1. Conservation Commission Agenda

# AGENDA
# March 12, 2026
# 7:00 PM

**RE: "Tanglewood Estates II" Symphony Drive Extension Definitive Plan**

On behalf of my client, Cypress Real Estate Development, LLC, I am submitting herewith a revised definitive plan and notice of intent. The modifications to the plan and report are as a result of the comments received by the Town's professional consultant BETA through a memo dated February 13, 2026. For ease of review, we have included the comment and our response.

# Property Line Plan

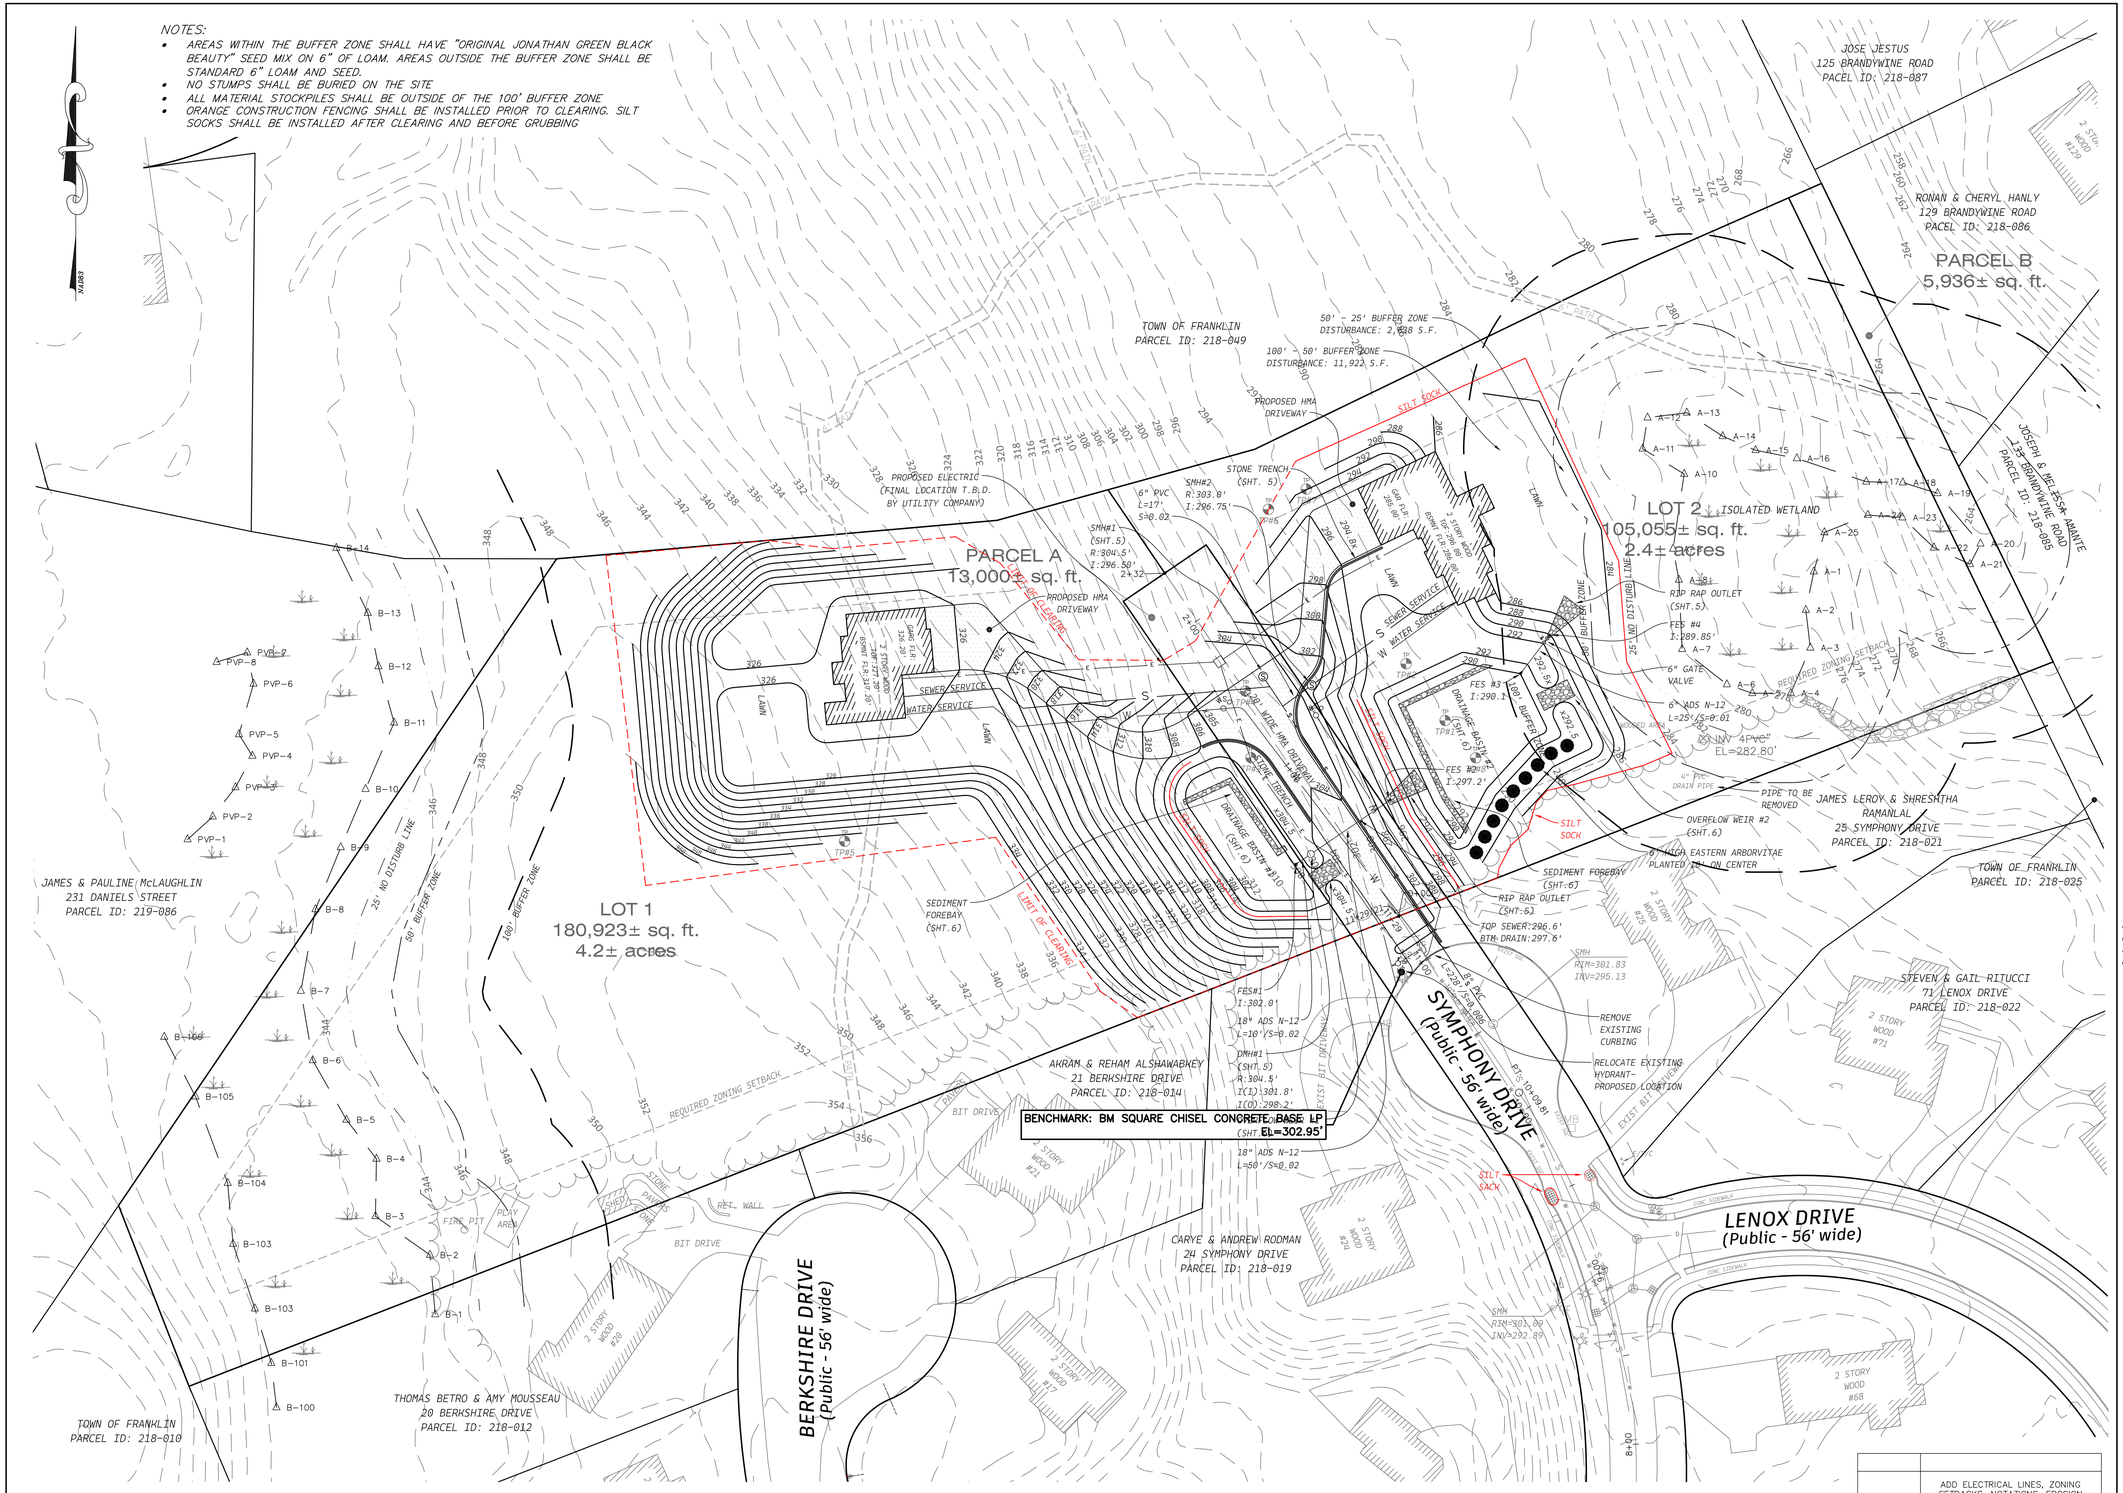
- **Recreation - A 20’ wide parcel (Parcel B) has been created east of Lot 2 to connect the Tanglewood Estates open space to the Town of Franklin land north of the site (Sheet 3).**
